Application for Variation of an Environmental Permit

**C2. Application No. of the Current Environmental Permit :** FEP-192/2019  
.....

Project Title  
**First Stage of Desalination Plant at Tseung Kwan O - Investigation, Design and Construction**

Figure Title  
**Revised Figure 1 - Project Location Plan**

Figure 1.1 Proposed Alignment of TKO Fresh Water Mains

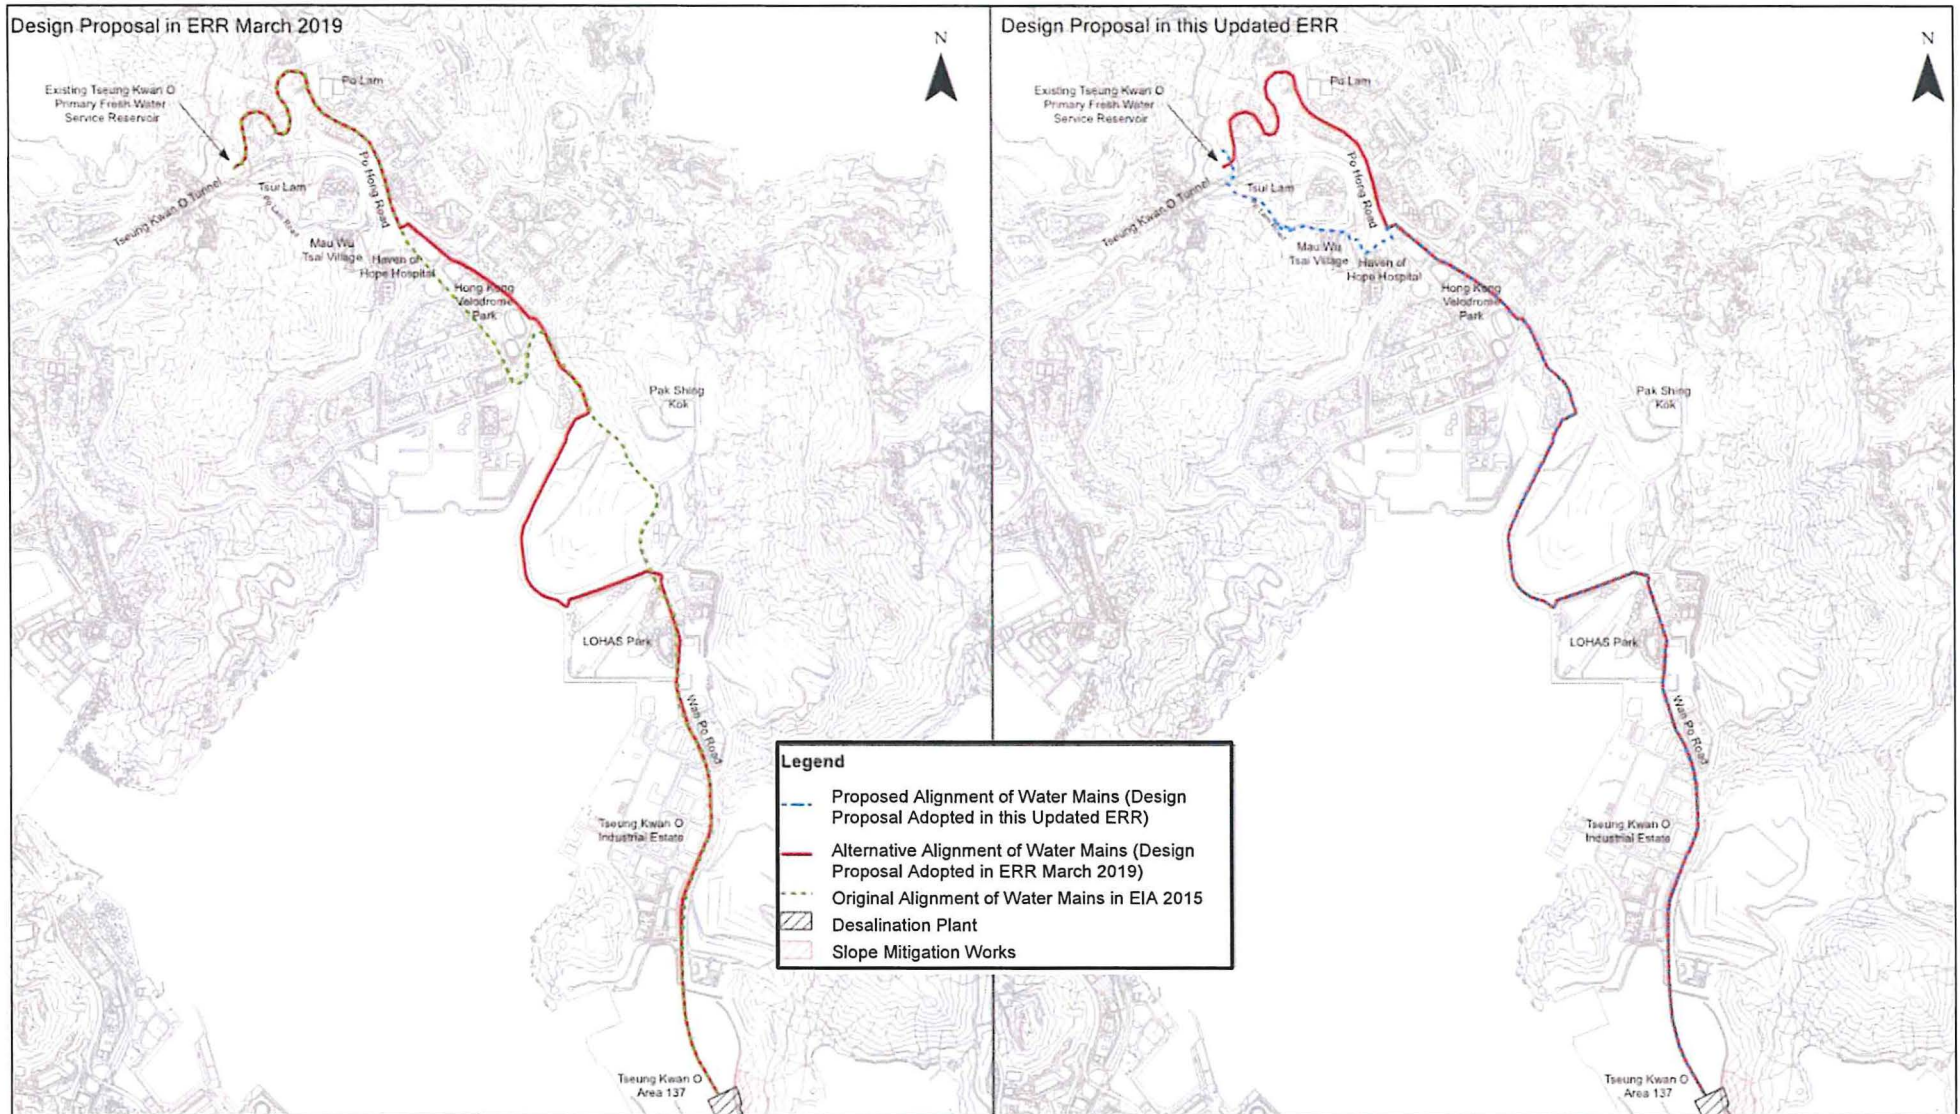
- 1.1.4 Change of the design and alignment of the fresh water mains was proposed in early 2019 under the detailed design works to resolve engineering constraints. An environmental review was carried out in early 2019 to assess the environmental impacts arising from the design change. The results of the environmental review are presented in “*Agreement No. CE 8/2015 (WS) First Stage of Desalination Plant at TKO – Investigation, Design and Construction, Environmental Review Report for Fresh Water Mains*” issued to the Environmental Protection Department (EPD) in March 2019 (hereafter also referred to as “ERR March 2019”). The Design Proposal adopted in the ERR March 2019 is also presented in **Figure 1.1**.

- 1.1.5 Recently, the need of further changing the alignment and design of the fresh water mains in the northern section close to the existing TKOFWPSR in Tsui Lam has been identified to resolve traffic constraints. This further change was not considered in the ERR March 2019.

- 1.2.1 The purpose of this Updated Environmental Review Report (ERR) is to review the potential environmental impacts arising from the latest change of the alignment and design of the fresh water mains in Tsui Lam and demonstrate that this change will not constitute material change to the environmental impact of the Project with mitigation measures in place and the Project complies with the requirements described in the Technical Memorandum on EIA Process (EIAO-TM). The proposed alignment adopted in this Updated ERR is presented in **Figure 1.1** for comparison with the alignment adopted in the ERR March 2019.

Figure 2.1 Design Proposal of TKO Fresh Water Mains in Tsui Lam Area

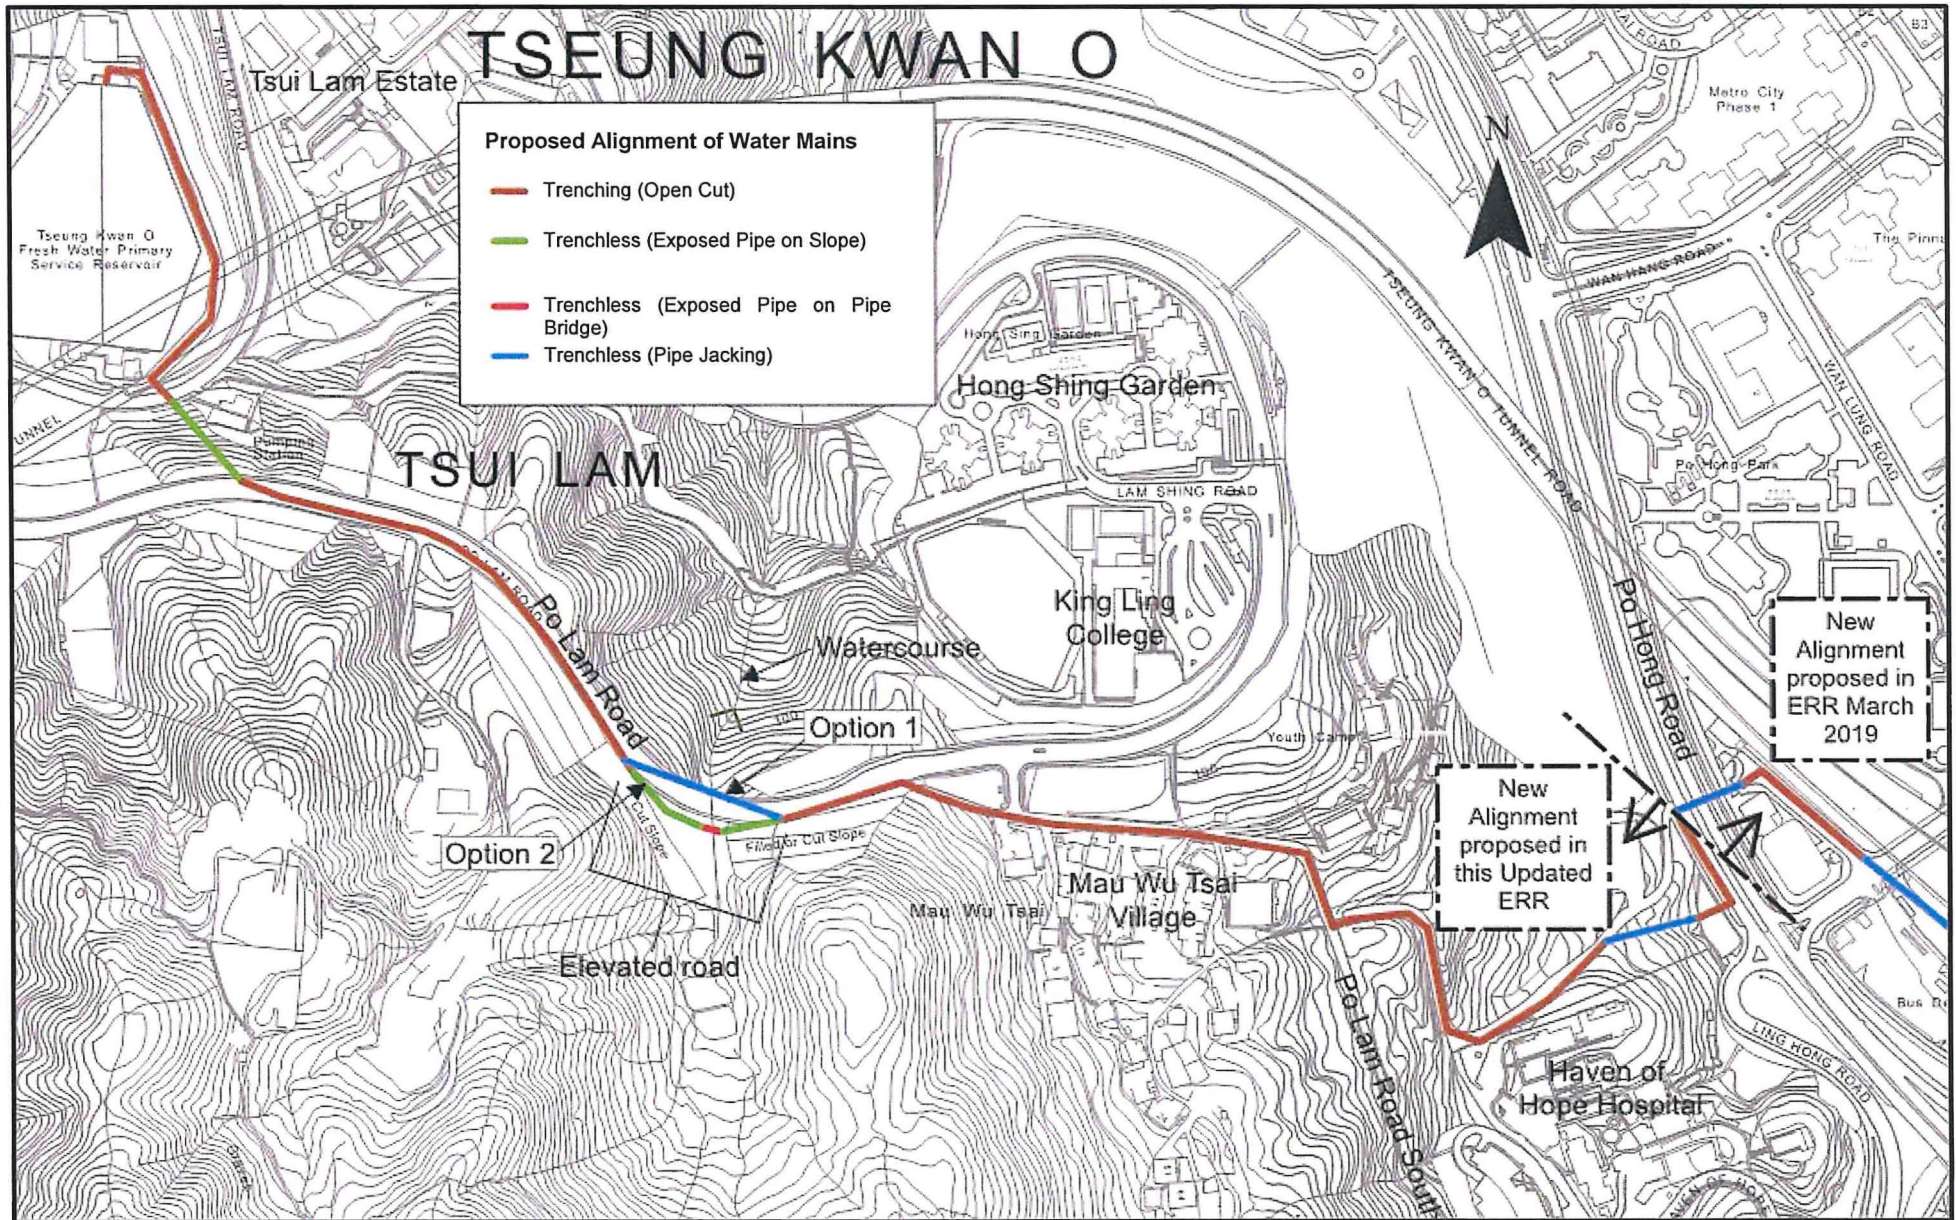
- 2.4.2 The proposed realignment in the north, namely Section C, is shown in **Figure 2.1**. This alignment would run across three areas of plantation. The western one is located on a slope south of TKOFWPSR, while the eastern one located near Po Hong Road. The third one is in the middle near the elevated section of Po Lam Road with a small watercourse running underneath the road from the south. Laying exposed pipe will be used in the western plantation patch. This method can avoid tree felling and major vegetation clearance and therefore is able to prevent habitat loss. Pipe jacking is proposed for the middle plantation patch (under Option 1) as well as on the eastern plantation patch near Po Hong Road. The whole water main will be installed underground by jacking and therefore can completely avoid vegetation clearance and surface disturbance.

- 2.4.3 The length of the pipe jacking section at Po Lam Road (Option 1) as shown in **Figure 2.1** is tentative but in any case, all surface works areas (jacking pits) would be located within existing roads only. Section plan which shows the typical work arrangement under Option 1 is provided in **Appendix 2A**.

### Annex 2 – Deviation of Fresh Water Main Alignment No. 2

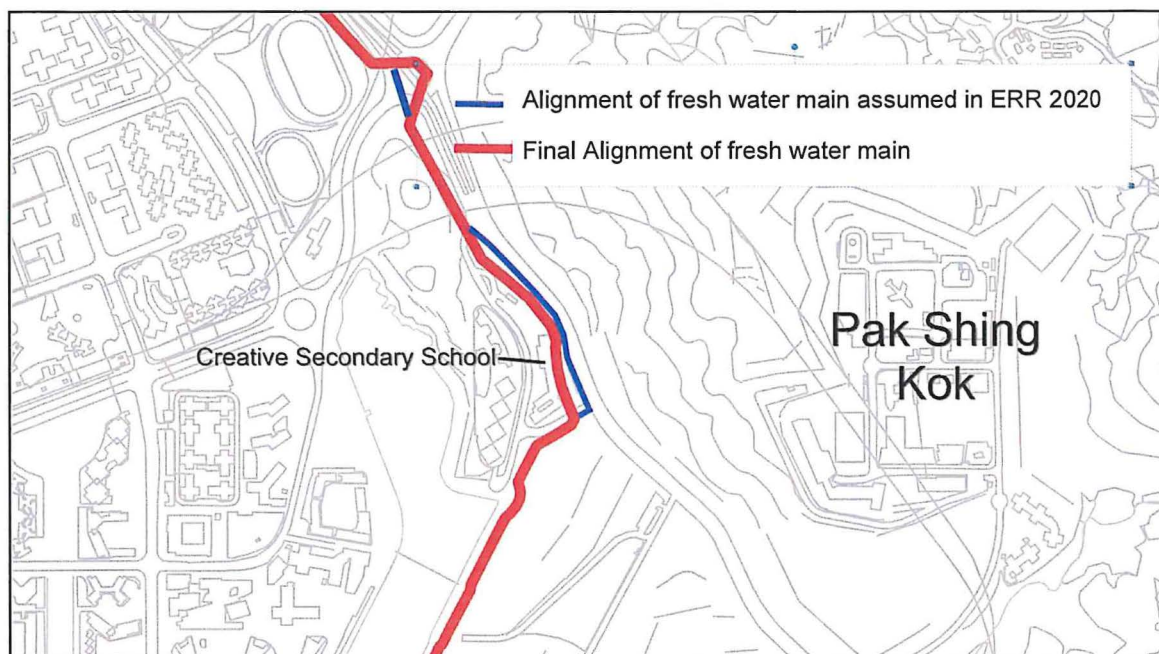
The final alignment of the fresh water main runs through Shek Kok Road, which was not considered in the ERR 2020 as illustrated in the figure below.

### Annex 3 – Deviation of Fresh Water Main Alignment No. 3

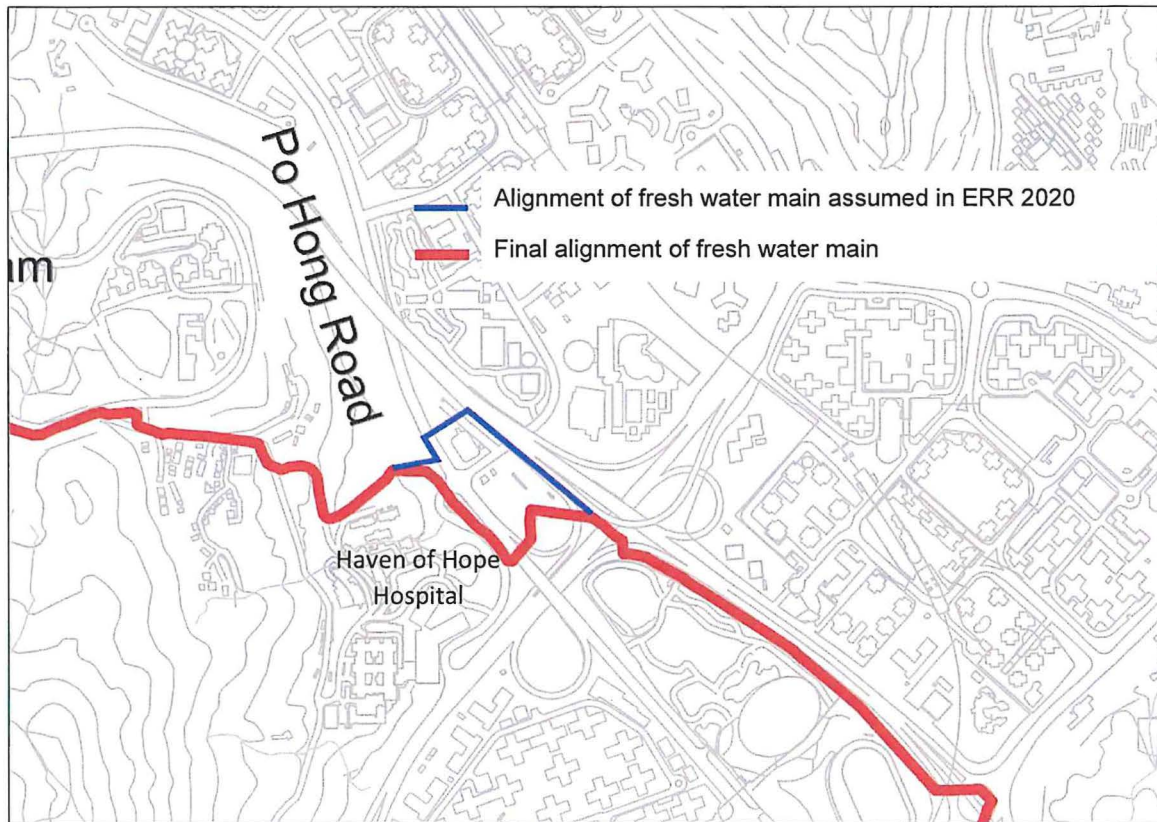
The final alignment of the fresh water main runs closer to the Creative Secondary School, which was not considered in the ERR 2020 as illustrated in the figure below.

### Annex 4 – Deviation of Fresh Water Main Alignment No. 4

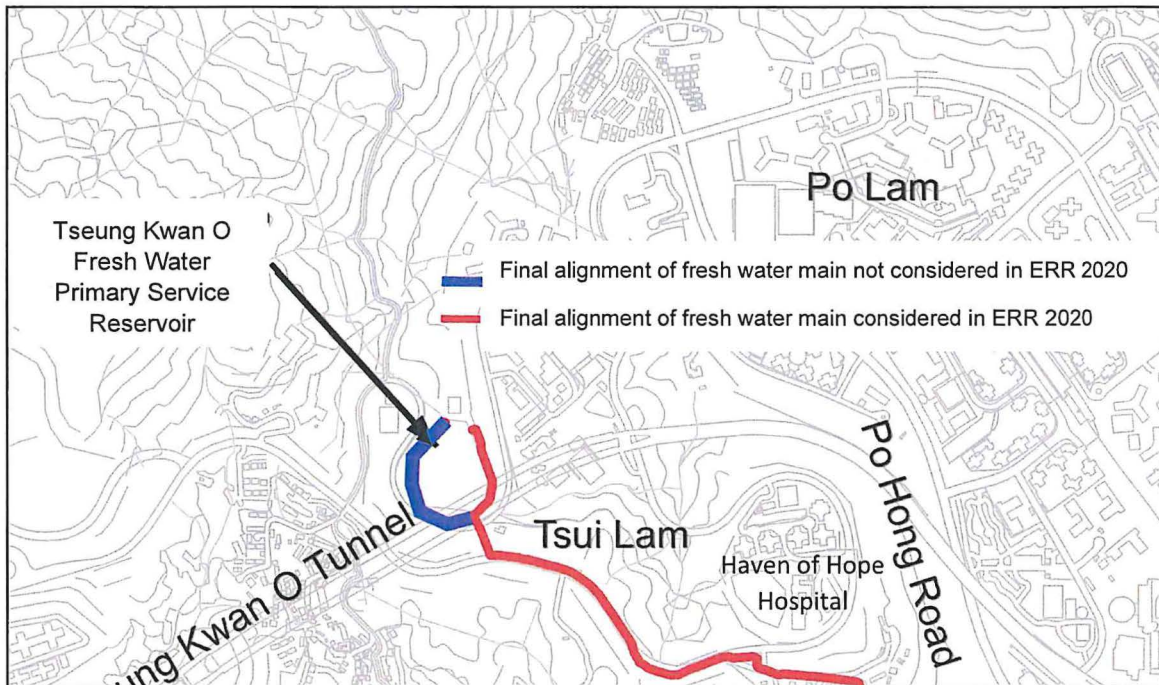
The final alignment of the fresh water main runs closer to the Haven of Hope Hospital, which was not considered in the ERR 2020 as illustrated in the figure below.
